MODIFICATION TO PROJECT APPROVAL-
HEIGHT INCREASE AND HELIPAD ON
ACUTE HOSPITAL BUILDING

MP08_00172

Royal North Shore Hospital

August 2010

Figure 2 - Level 11 Helipad Plan, prepared by BVN.

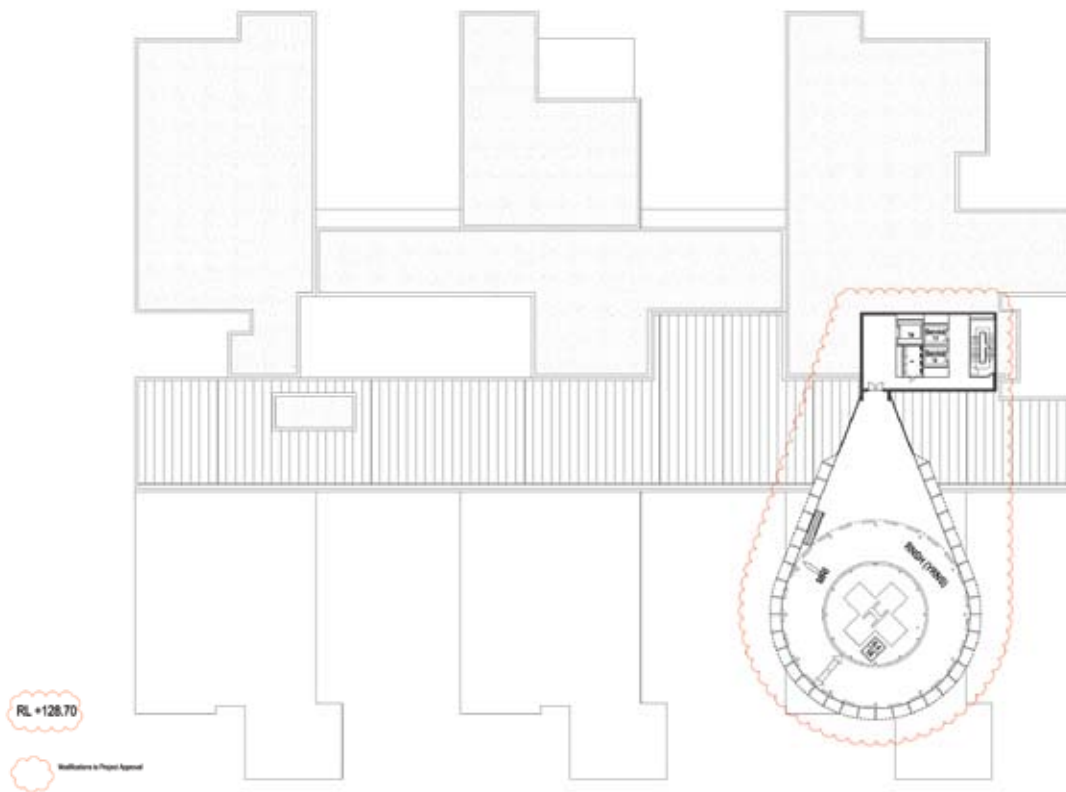
As discussed in the Background to this report, the helipad is required for clinical reasons to facilitate the most efficient and speedy delivery of patients to the Emergency Department, ICU and operating theatres. The proposed Helipad is located on Level 11 in the south east corner of the new Acute Hospital building, which is currently under construction.

The floor to ceiling heights of levels 3, 4, and 5 of the Acute Hospital building have been increased by 300mm each, resulting in an overall increase to the building height of 900mm. This design amendment is required for the provision of services between the ceiling and floor spaces at these levels.

Figure 5 - North South Section 01

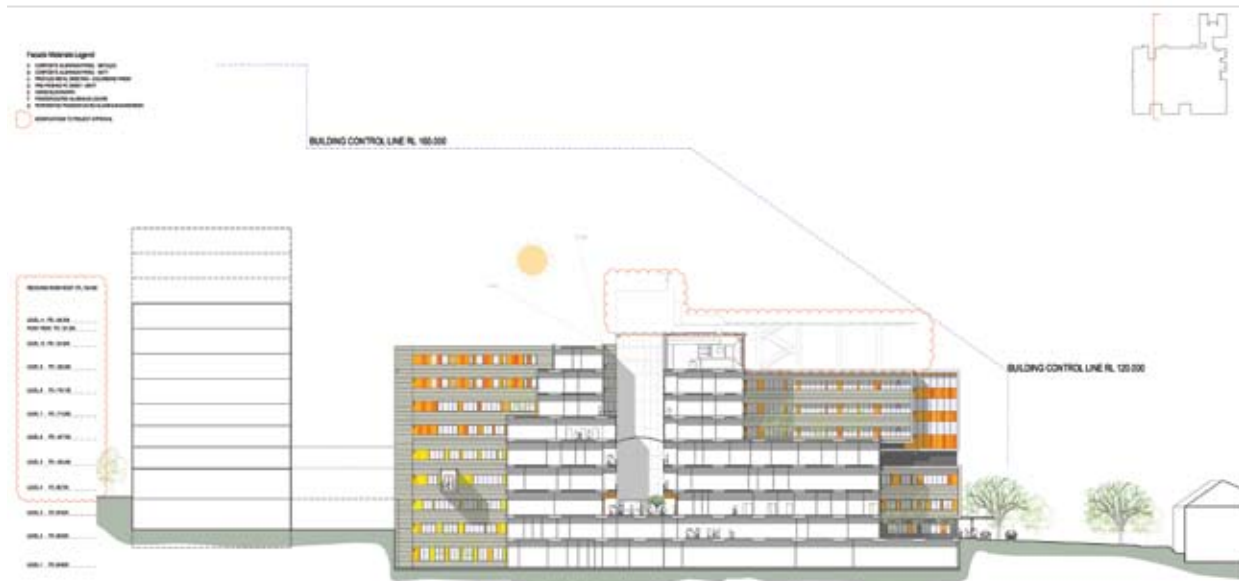
The proposed helipad is located wholly within the Building Height Control Line which was determined during the original Concept Approval process. The location of the proposed helipad in relation to the Building Height Control Line is clearly illustrated in **Figure 5**.

The proposed increase in height of the Acute Hospital Building by 900mm is within the prescribed building envelope.

Figure 6 - Shadow Diagram June 22 – 3pm

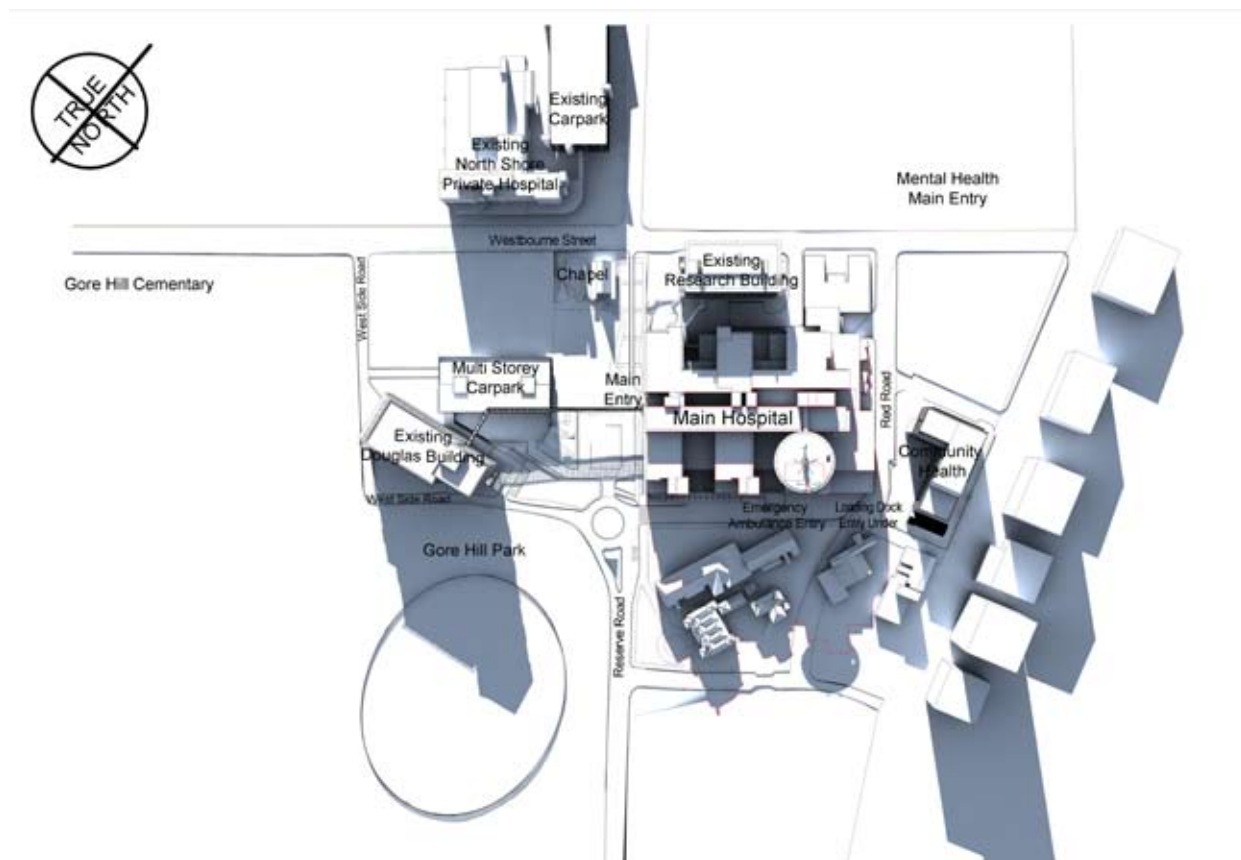
C3D Interactive has prepared shadow diagrams comparing shadows from the approved building (shown in red) with shadows created by the slightly higher building and helipad structure. The shadow diagrams clearly indicate that the overshadowing impact of the proposed modification is not significant. A complete set of shadow diagrams is included in **Appendix E. Figure 6** shows the shadow (mid-winter) at 3pm which represents the worst case shadow in terms of potential shadow impact. It is clear that shadows created by the proposed modification do not impact on nearby dwellings and the area that will be most greatly affected is earmarked for approximately 24,000 square metres of commercial development under the Concept Approval.

Figure 7 - Acute Hospital Helipad Approach Plan – Local Context

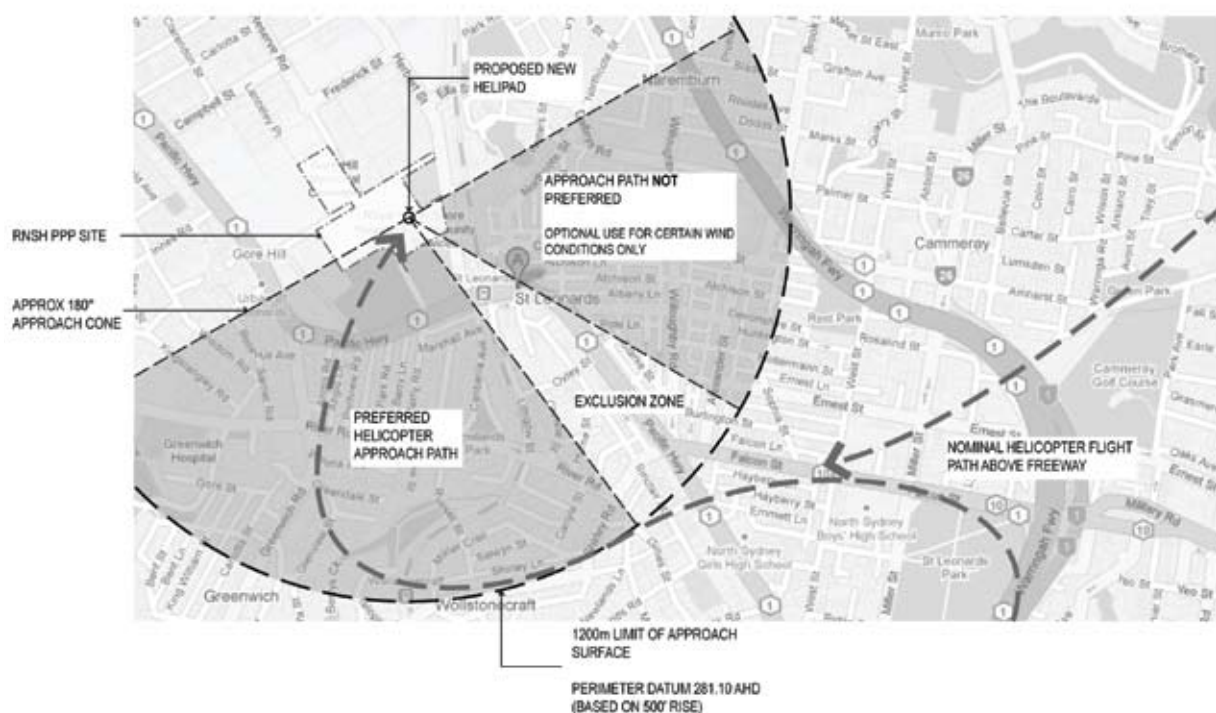
Helicopters will approach and depart the new helipad by one of two approach and departure arcs. The arcs have been determined based on an analysis of the prevailing wind conditions and taking account of existing surrounding development and the development potential of surrounding land. This analysis has included a review of the Willoughby LEP 1995, the draft Willoughby LEP 2009, the LC LEP, North Sydney LEP 2001 and Concept Plan height limits. A plan has been prepared showing the available approach and departure “arcs” and the primary (preferred) flight path. The plan is included as **Figure 7** with other details provided at **Appendix F**.

An Aviation Report has been prepared by Avipro and is included in **Appendix G**. The Avipro Report determined the appropriate flight paths to be used by helicopters accessing the new helipad. The report has confirmed that the proposed approach and departure arcs and flight paths shown on **Figure 7** are acceptable. The report states:

“Two approach and departure arcs of approximately 125 – 225 degrees and 045 -100 degrees Magnetic have been proposed. The suggested primary flight path (preferred flight path) is within the arc 125-225 degrees, with an approach direction of approximately 355 degrees and a departure direction of approximately 175 degrees. It appears that these arcs and proposed flight paths provide acceptable VFR Approach/Departure and Transitional Surfaces. The arc 045 -100 degrees (non-preferred path) would only be used under extenuating weather conditions due to the proximity of occupied dwellings and commercial premises.”
